Support the Shift to Electric Mobility in Madagascar

Review CEO Endorsement and Make a recommendation

GEF ID 10275 **Countries** Madagascar **Project Name** Support the Shift to Electric Mobility in Madagascar **Agencies UNEP** Date received by PM 1/30/2023 Review completed by PM 4/5/2023 **Program Manager** Filippo Berardi **Focal Area** Climate Change **Project Type MSP**

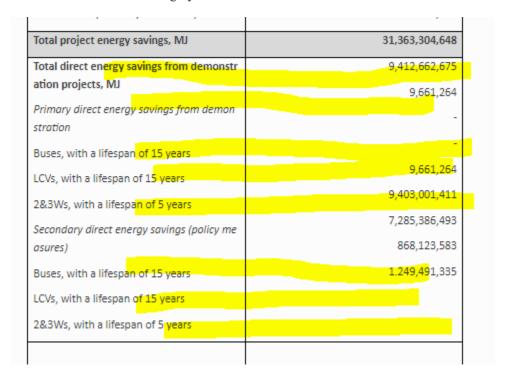
Also, Table 30 includes information that are not aligned in the two columns, so it's not clear which data refers to which category. Please amend:

Table 30 has been reformatted. There were errors in the reported indirect energy saving figures, which have been corrected now (highlighted in yellow). A similar table in Annex M already presented the right figures and did not need any corrections.
